ADDENDUM No. 3

City of Austin

Project Name: Todd Lane Improvements from Ben White to Saint Elmo

C.I.P. No. 6755.002

TRAFFIC CONTROL PLAN
PHASE 3 - ROUNDABOUT

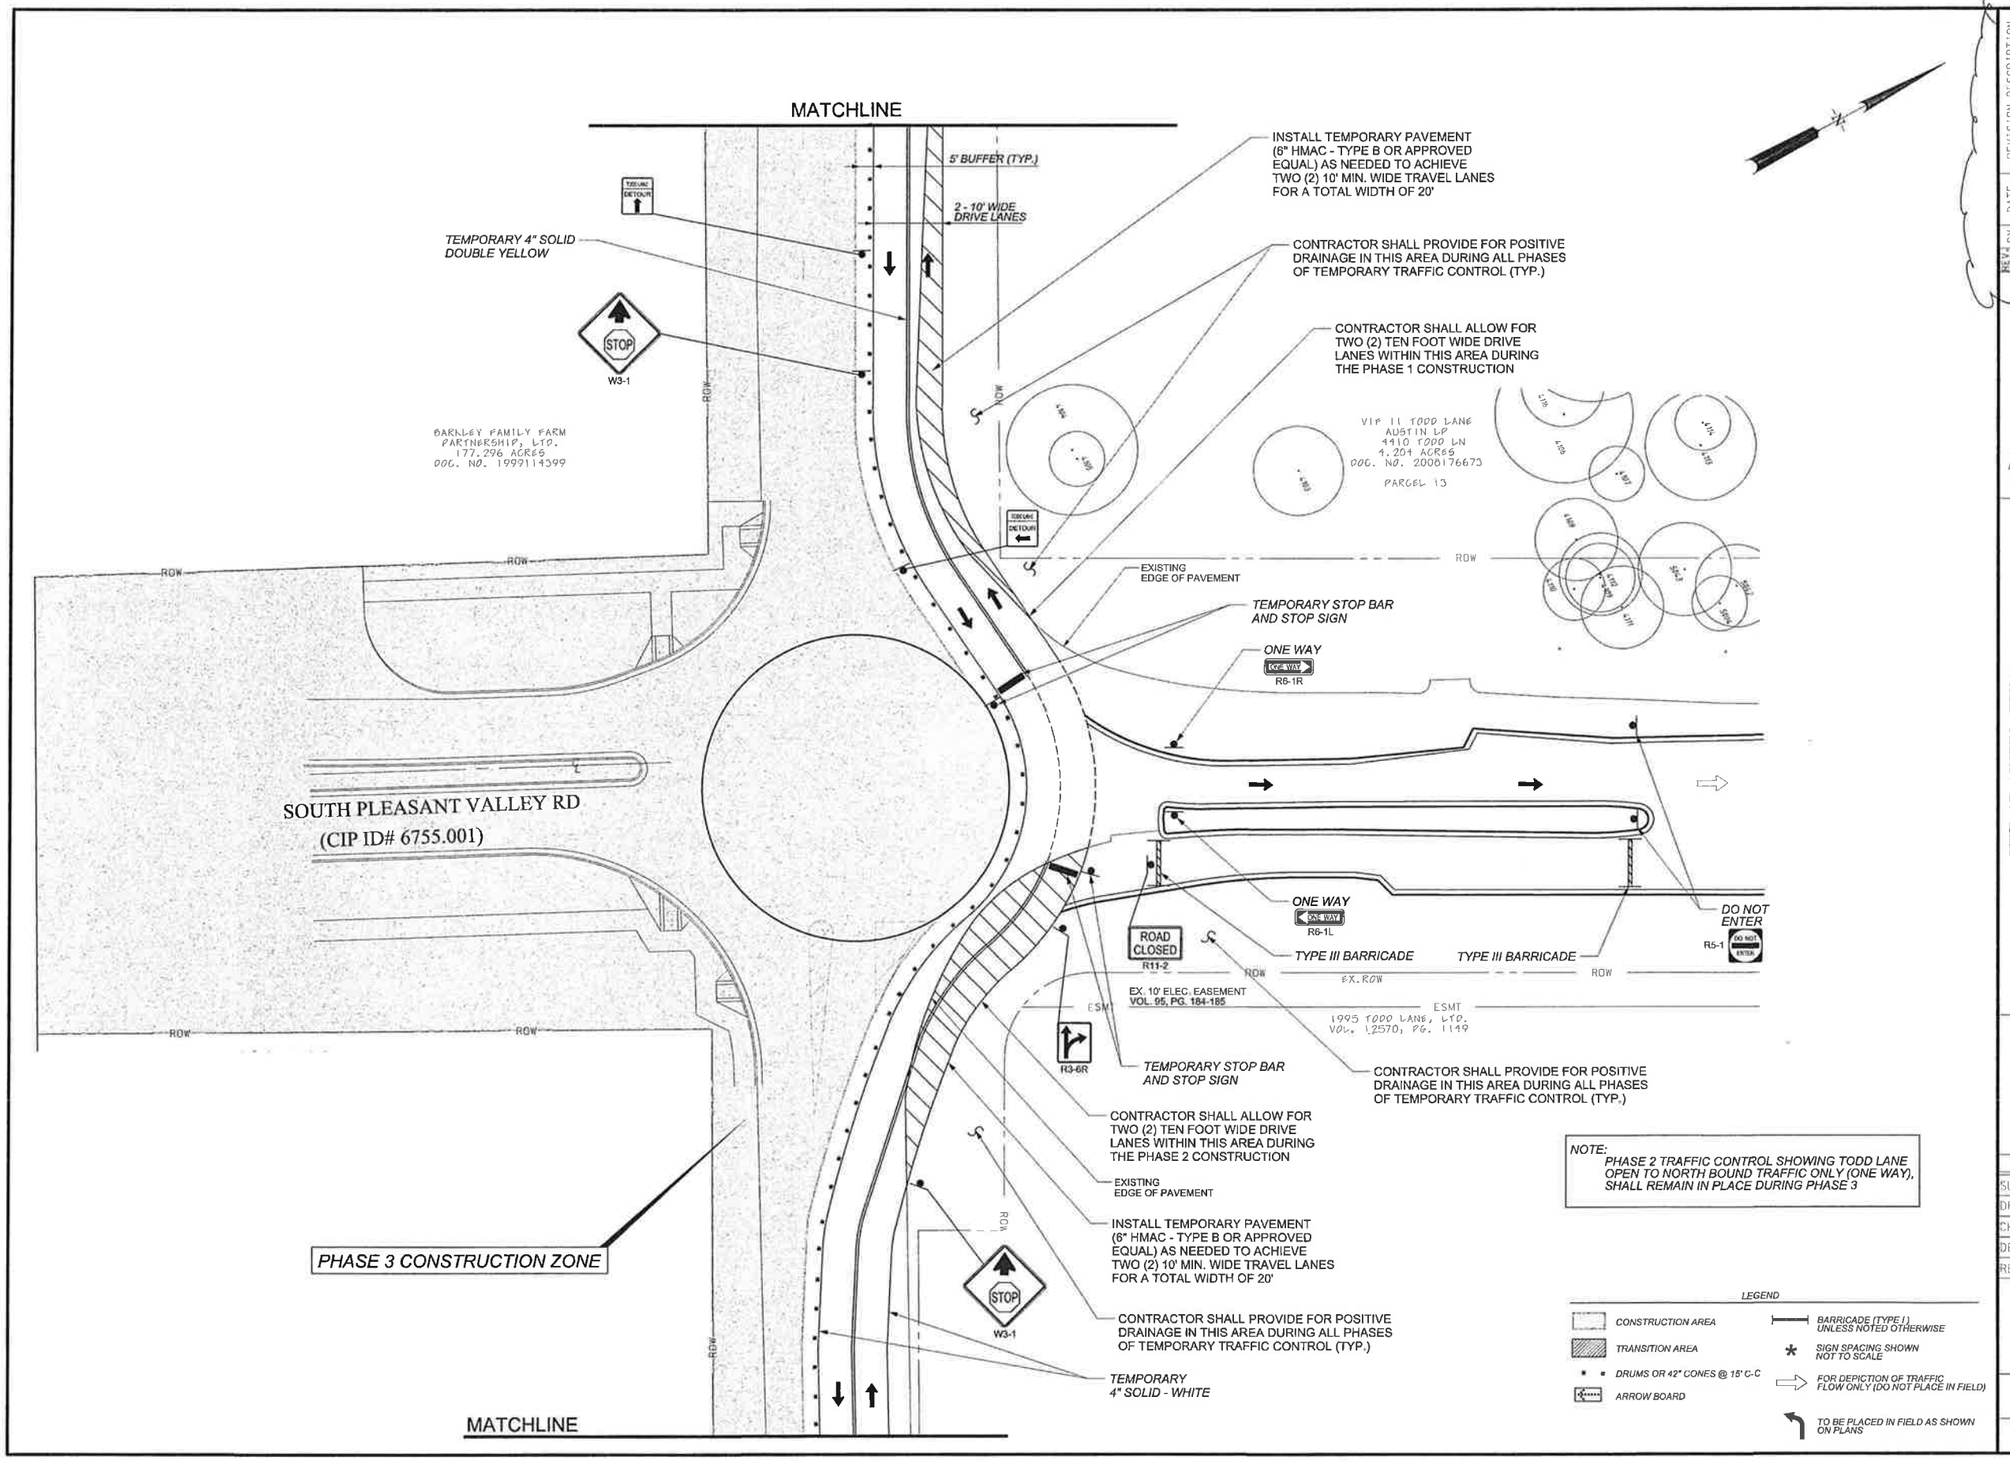
REV# NO.	BY	DATE	REVISION DESCRIPTION
1	EZ	04/01/13	ADD ROUNDABOUT TRAFFIC CONTROL PLAN - SHEET 172 - ADDENDUM #3

NOTE:
PHASE 2 TRAFFIC CONTROL SHOWING TODD LANE OPEN TO NORTH BOUND TRAFFIC ONLY (ONE WAY), SHALL REMAIN IN PLACE DURING PHASE 3

TRAFFIC CONTROL PLAN
PHASE 4 - ROUNDABOUT

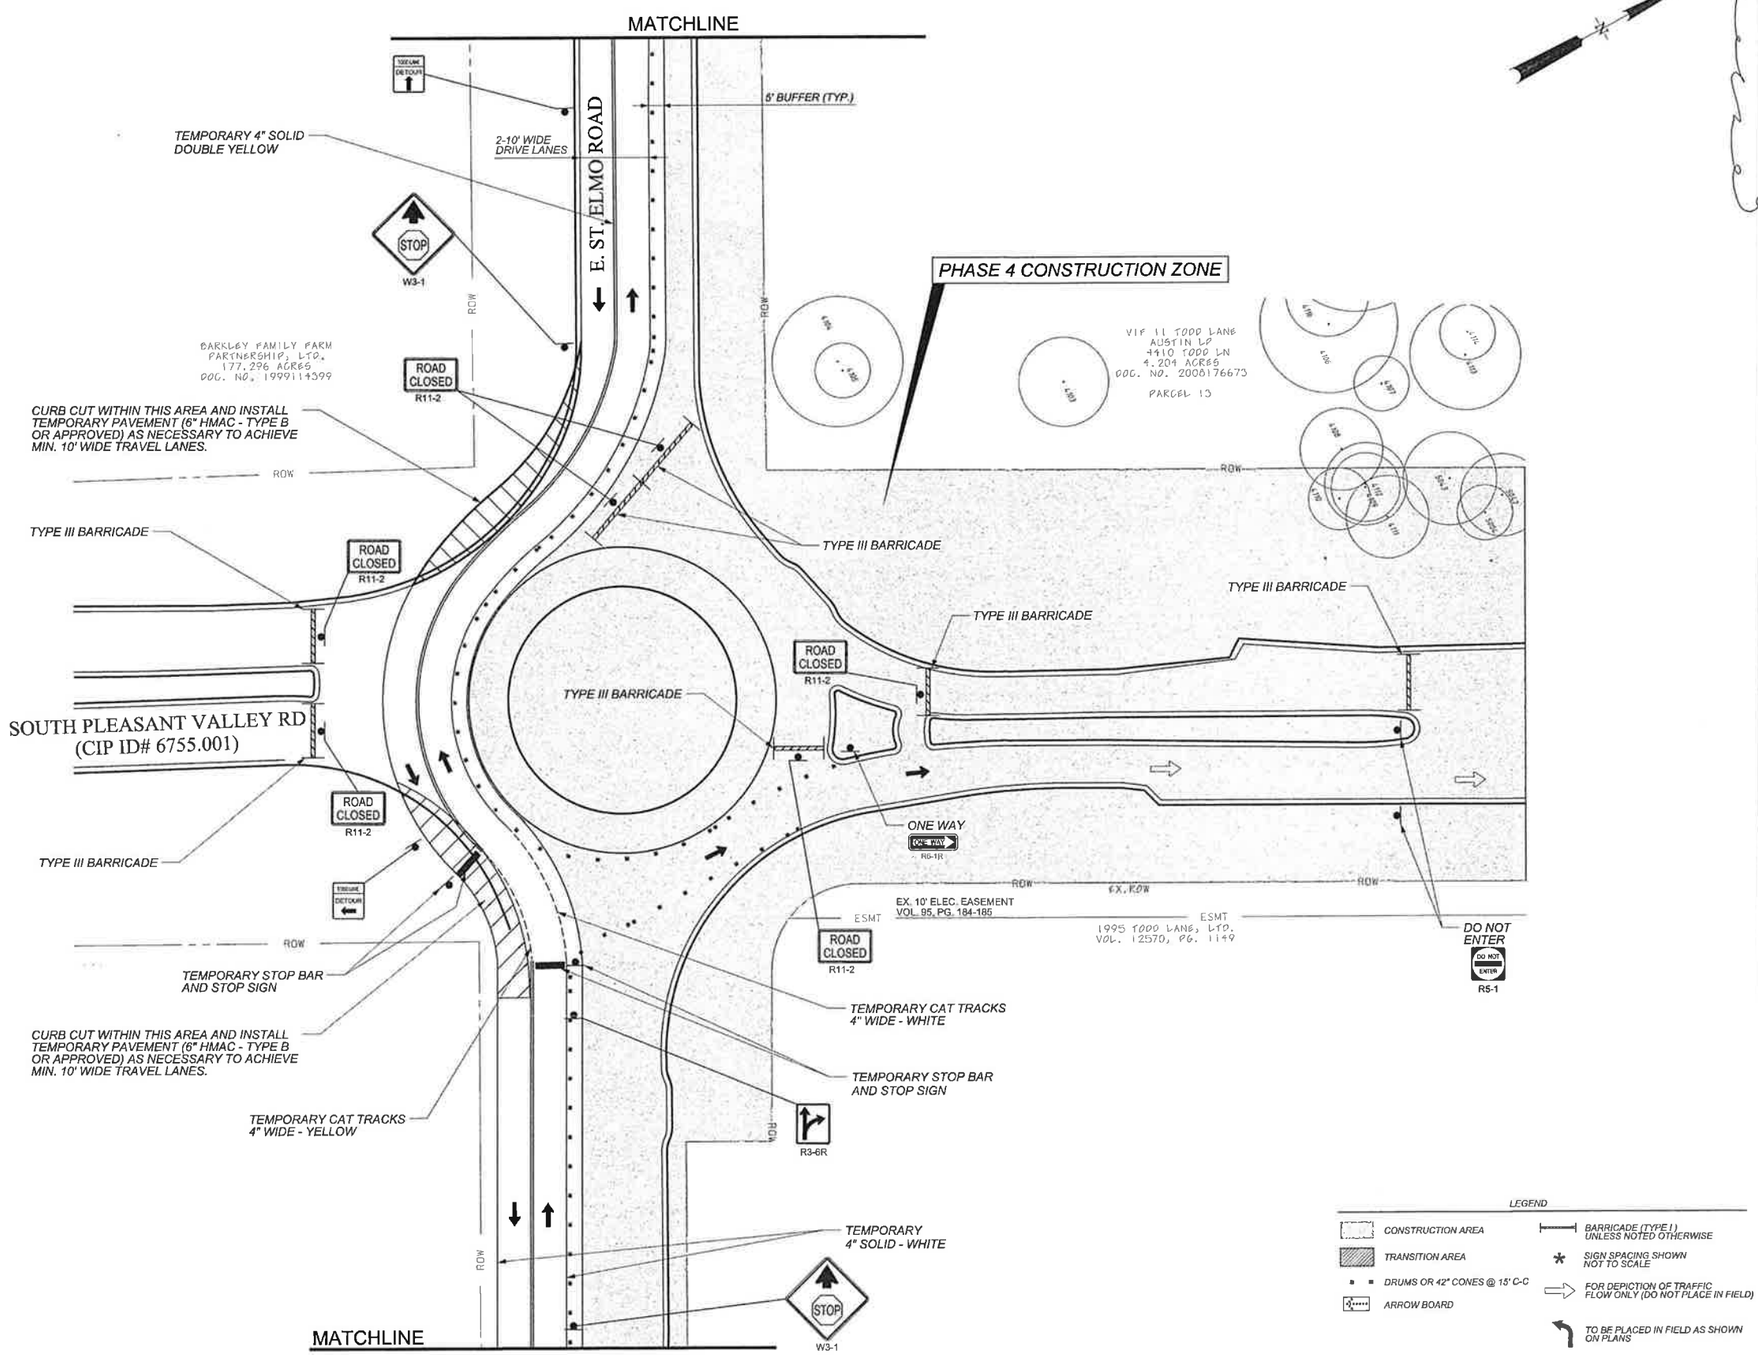
REV. NO.	BY	DATE	REVISION DESCRIPTION
	EZ	04/17/13	ADD ROUNDABOUT TRAFFIC CONTROL PLAN SHEET 173 - ADDED DEVICES

TRAFFIC CONTROL PLAN
PHASE 3 - ST. ELMO ROAD

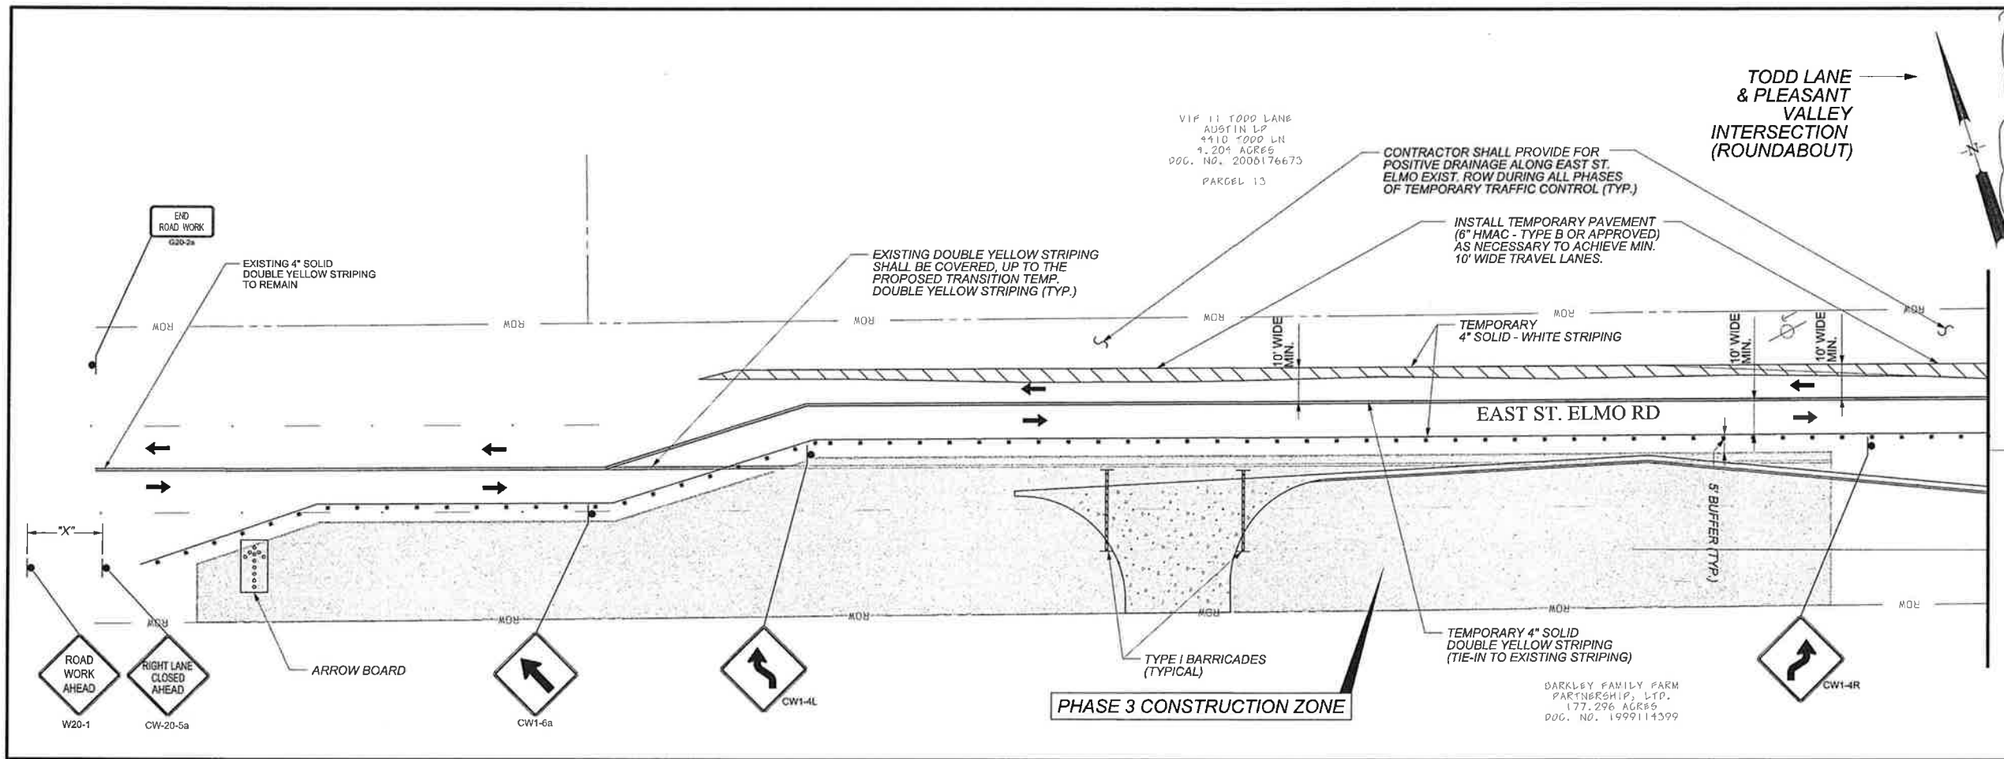
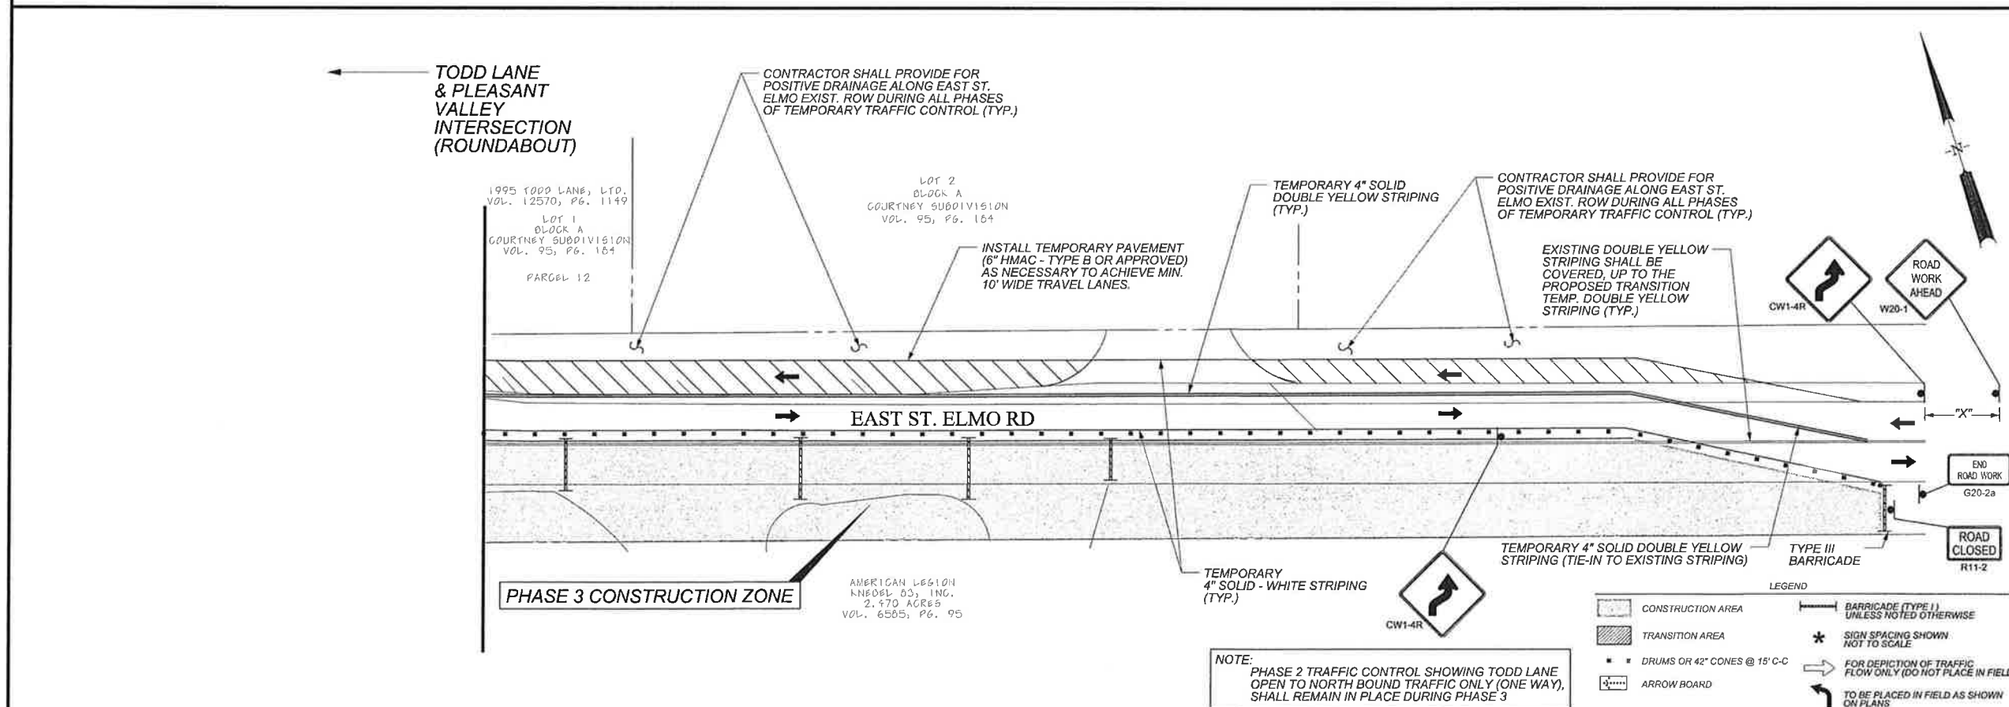
REV NO.	BY	DATE	REVISION DESCRIPTION
1	EZ	04/17/13	ADD ROUNDABOUT TRAFFIC CONTROL PLAN SHEET 174 - ADDENDUM 3

NOTE:
PHASE 2 TRAFFIC CONTROL SHOWING TODD LANE OPEN TO NORTH BOUND TRAFFIC ONLY (ONE WAY), SHALL REMAIN IN PLACE DURING PHASE 3

TRAFFIC CONTROL PLAN
PHASE 4 - ST. ELMO ROAD

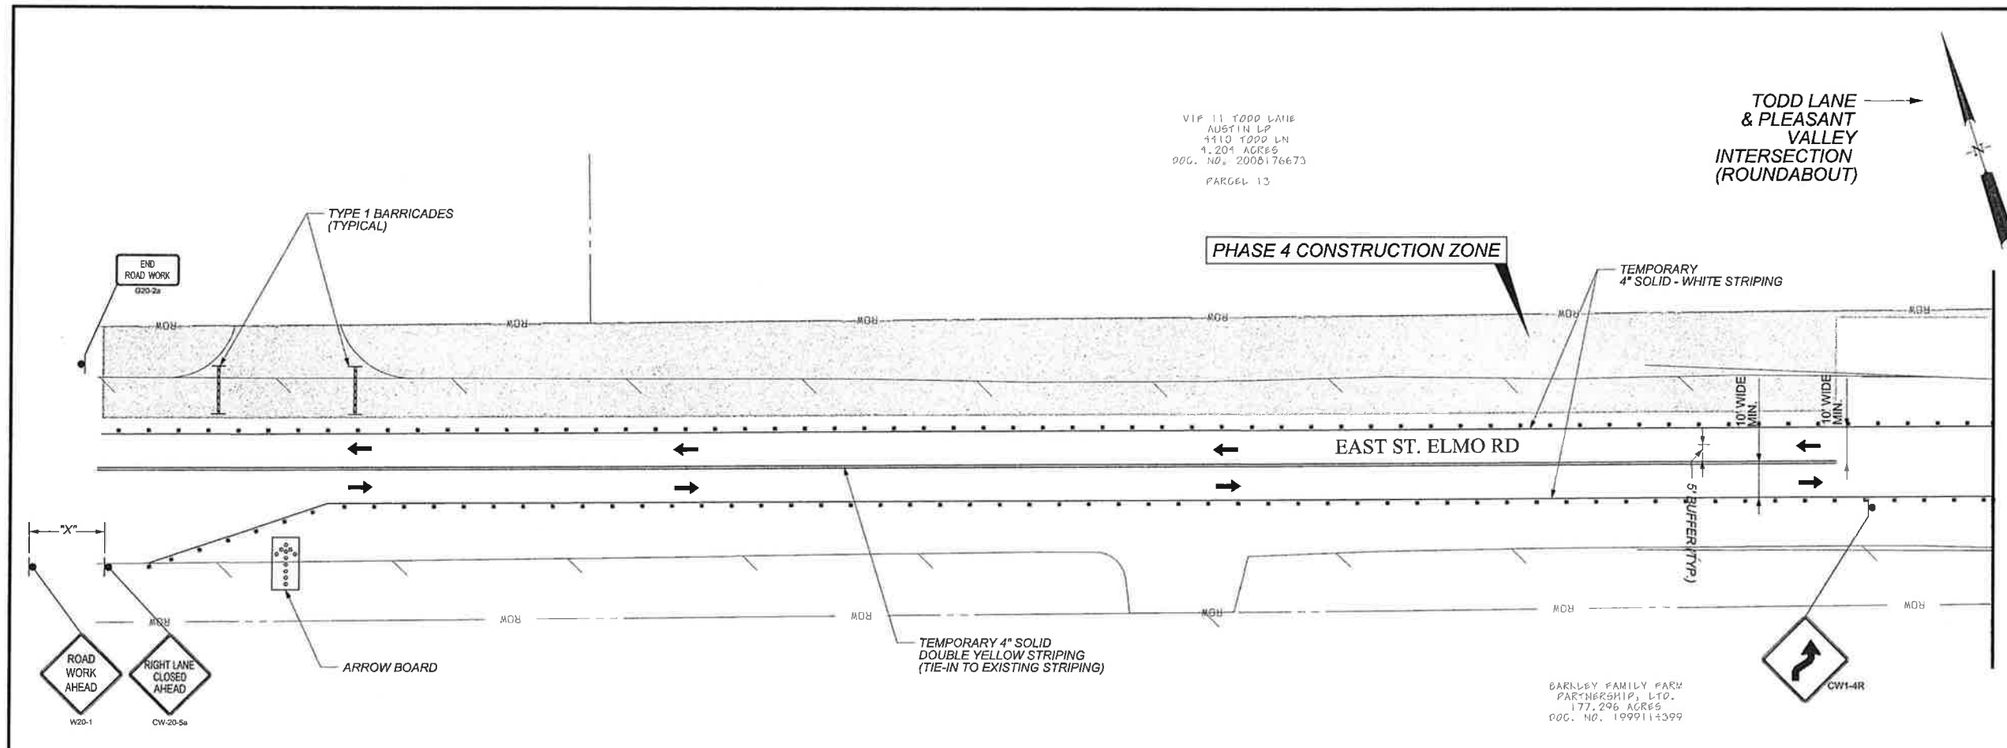
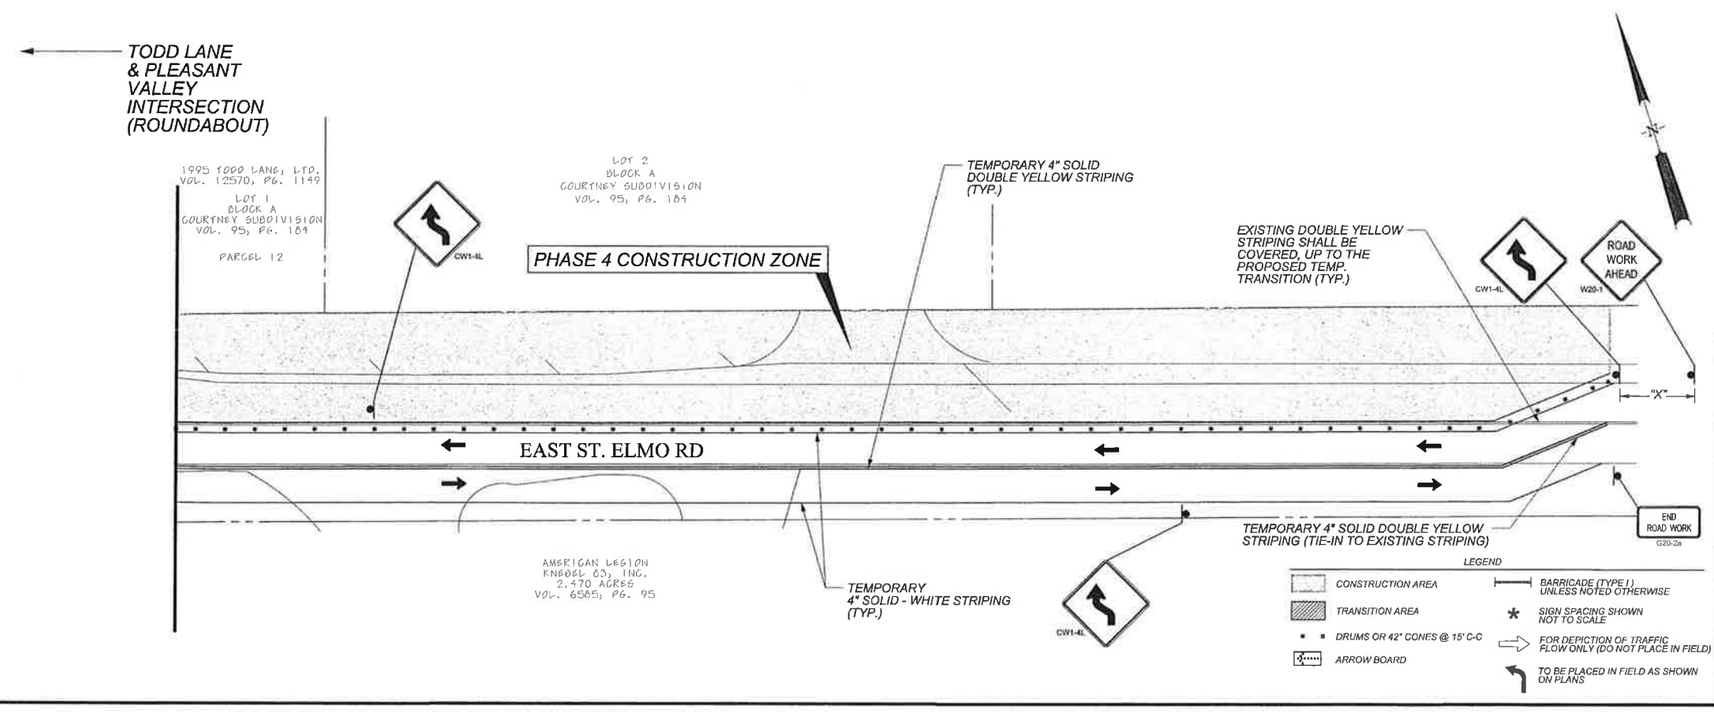
REV. NO.	BY	DATE	REVISION DESCRIPTION
1	EZ	04/17/13	ADD ROUNDABOUT TRAFFIC CONTROL PLAN SHEET 175 - ADDENDUM 3
